ASSESSMENT REPORT

PROPOSED MODIFICATION SYERSTON NICKEL COBALT PROJECT

Figure 2: Modified Processing Facility Layout

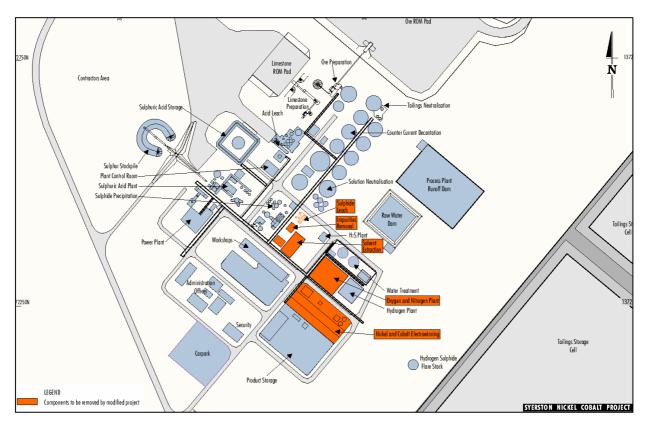
The removal of the refinery would reduce the Project's operational employment levels from 400 to 300. The proposal does not involve any significant changes to the footprint or layout of the MPF, apart from the removal of the metals refinery. The amended layout is shown on Figure 2.

Figure 4: Modified Quarry Layout

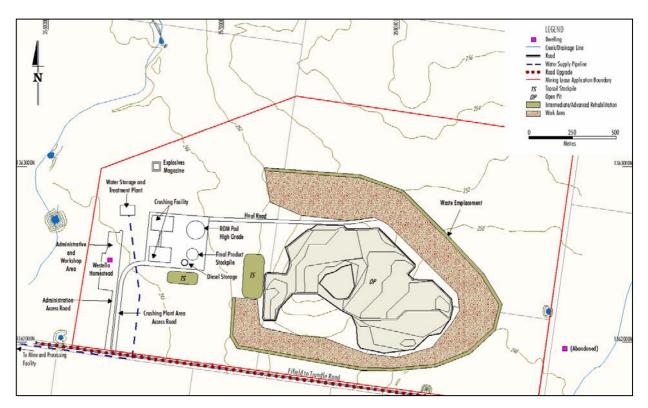
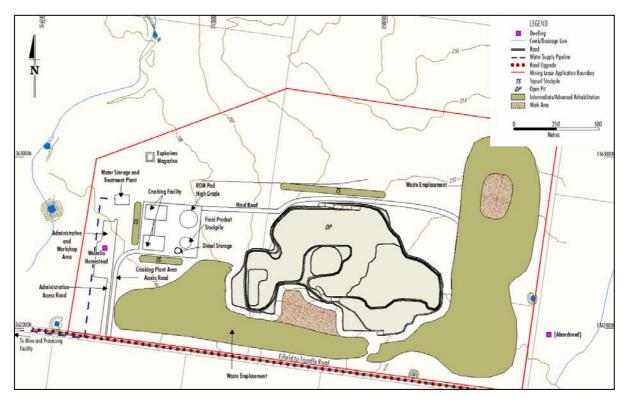
- An increase in the lateral area of the open pit from 46 hectares to 61 hectares; and
- An increase in the lateral area of the waste emplacements from 56 hectares to 110 hectares, and a change to the general layout of the emplacements.

The changes to the layout of the quarry are shown on Figure 3.
